## **PLAN REVIEW SHEET**

2014-082

**Brookwood Capital Partners**

Attachments: Bench Pad Detail

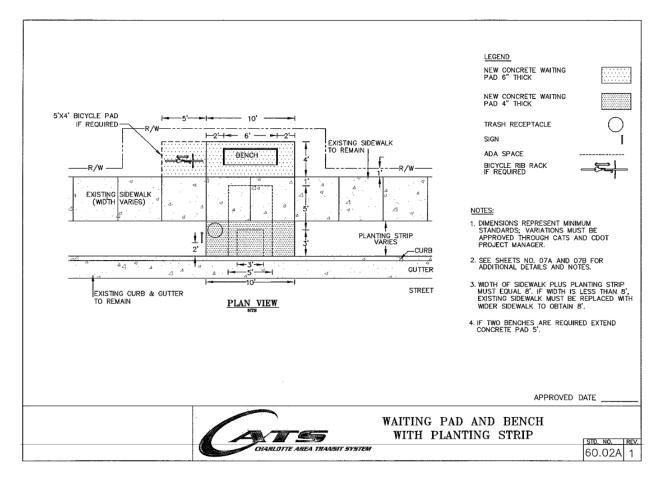
The Petitioner is requested to provide and construct a concrete bench pad for a new bus stop along Wilkinson Boulevard. Below is an image of the standard detail (60.02A) for the requested bus stop pad. The site plan may either show the conceptual location of the improved bus stop on Wilkinson Boulevard, or alternatively, include a development note to locate the bus stop pad during the development review and permitting process. Please note that the bicycle portion of the pad detail is optional.
